NO.	REVISION	DATE
1	ISSUED FOR TENDER	DEC 09/12
2	ISSUED FOR TENDER - AMENDMENT #1 FEB 25/13	
3		
4

Project Name: COLLINS BAY AND FRONTENAC INSTITUTION
1455 BATH ROAD, KINGSTON, ON K7L 4V9

Project Date: JAN 2011
Drawing No.: R.03192.001

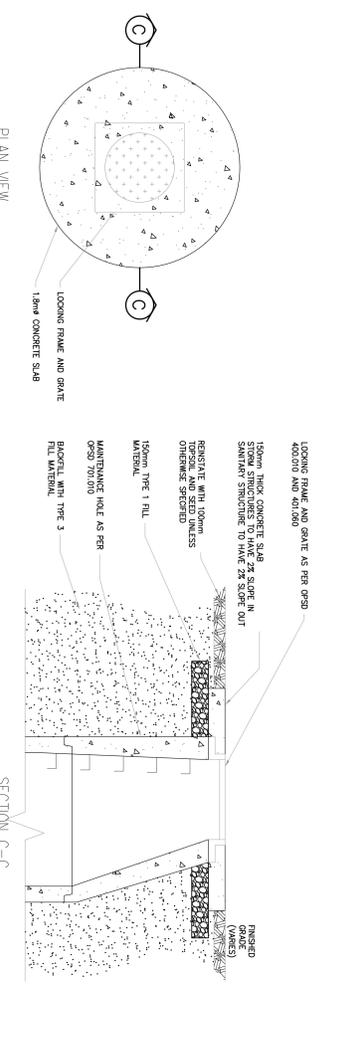
DETAIL MODIFIED TO ADD 2 BOLTS AS SPECIFIED
